# Memorandum

**Re:** 70 Beachside Avenue, Special Permit/Coastal Site Plan Appl. #PZ-21-00792

Fig 2. Section, [Site Plan by Sound Engineering, dated 2/16/25, revised 2/20/26](#)

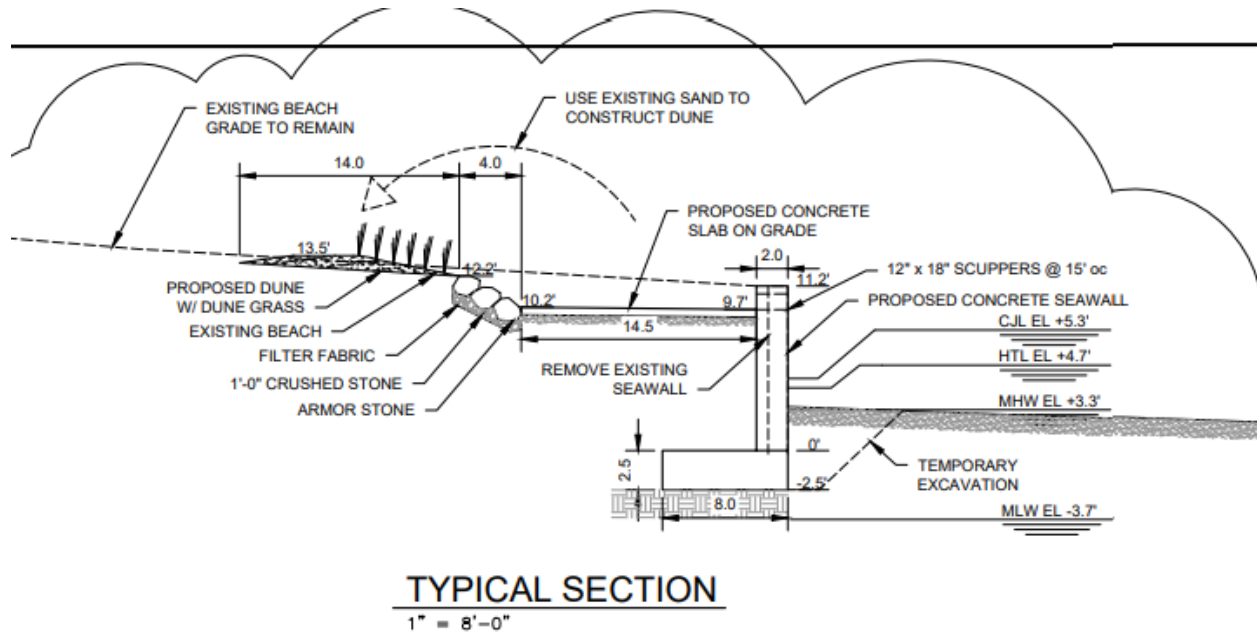
CGS 22a-109(d) requires an application for a Shoreline Flood and Erosion Control Structure be referred to the Commissioner of the Department of Energy and Environmental Protection so they can provide comments. Comments from John Gaucher, dated 2/20/26 were received indicating the improvements behind the seawall would not be considered a Flood and Erosion Control Structure with the recommended revisions which have been incorporated into the revised plan dated 2/20/26.

A 14 foot wide dune with native salt tolerant planting will be installed from the stone slope landward in order to stabilize the disturbed area, to provide habitat for wildlife and to intercept and absorb nutrients and prevent contaminants from reaching the adjacent coastal resources.
